Reference: Post Bid Addendum No. One to the Bidding Documents for:
Marbles Kids Museum and IMAX Theater
Roof Replacement
REI Project No. 021RAL-082

This addendum is to clarify contractual changes resulting from a value engineering review of the project requirements. The following clarifications, amendments, additions, deletions, revisions, and modifications are hereby made a part of the Contract Documents, and change the original documents only in the manner and to the extent stated below:

VALUE
ENGINEERING
OPTIONS

VE OPTION 01 - MECHANICALLY FASTEN
ALL INSULATION - AREAS A2, H, Q, & R

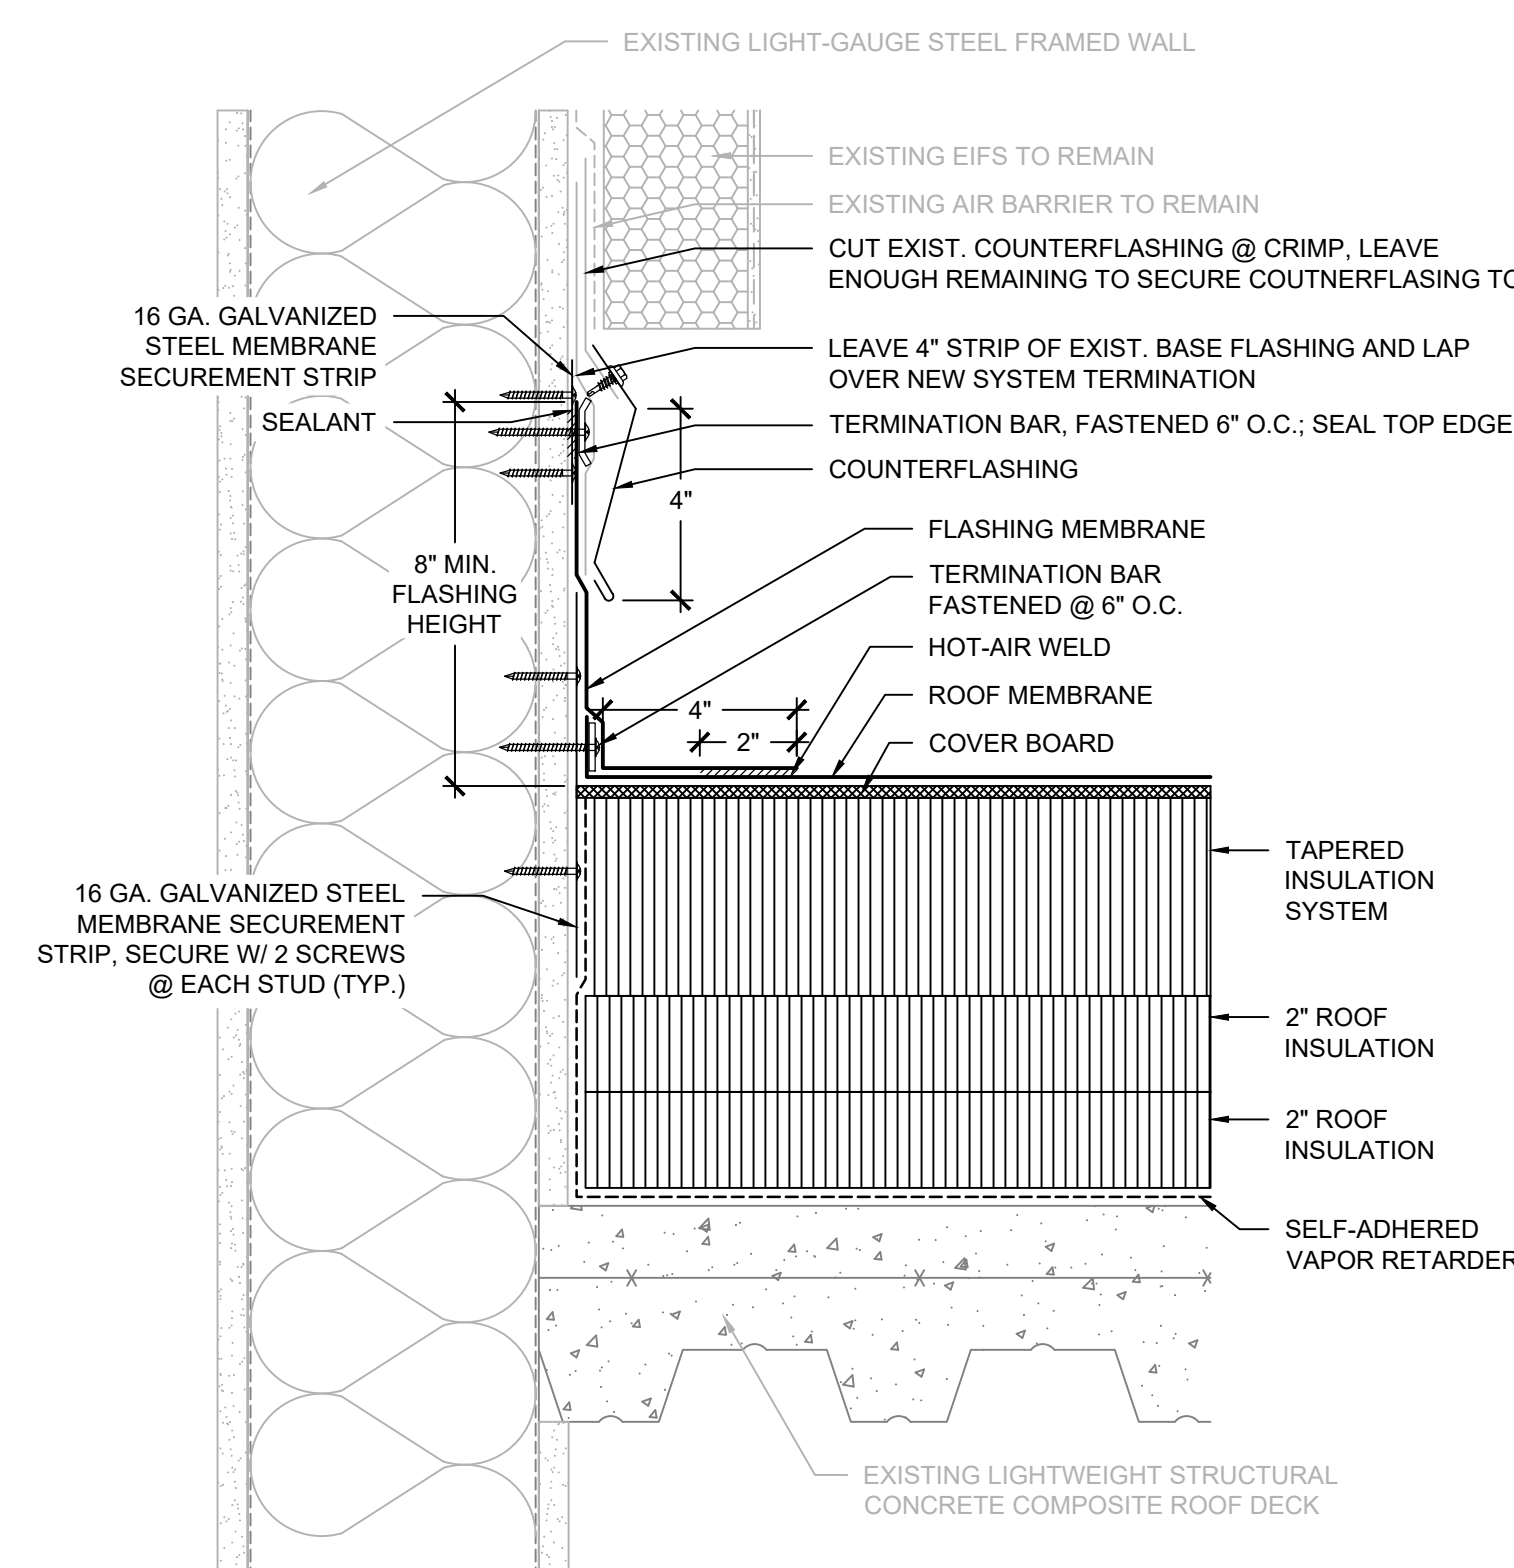
1. Value Engineering Option 01: Mechanically fasten (gang fasten) all roof insulation and gypsum substrate at roof sectors with steel roof deck.
 - a. DELETE Detail I/XR302, dated 6/15/2022.
 - b. ADD Detail 01/SK-1, dated 9/1/2022.
